NHTSA RECALL 19V534

AUTOCAR, LLC SAFETY RECALL ACX-1905

Autocar has determined that a safety issue exists with the service brake release timing on certain 2019-2020 model year Xpeditor's

This document contains information regarding the replacement and repositioning of specific pneumatic components to correct the brake release timing.

Figure 11

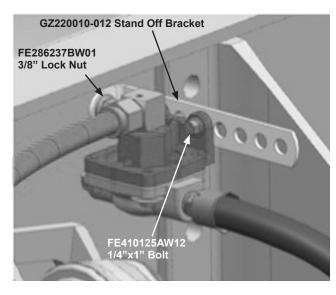
- 20. Disconnect the rubber service brake line and the nylon service brake line (green) from the anchor Tee fitting.
- 21. Remove the pipe plug and the tube adapter fitting from the anchor Tee and set aside for reinstallation. Discard the anchor Tee.
- 22. Install (1) GZ220010-012 stand off bracket into the right frame rail using (1) FE410137AW16 bolt and (1) FE286237BW01 nut (see Figure 11).
- 23. Install the remaining QRV (set aside in Step 3) to the stand off bracket using (2) FE410125AW12 bolts and (2) FE286225BW01 nuts (see Figures 11 and 12).
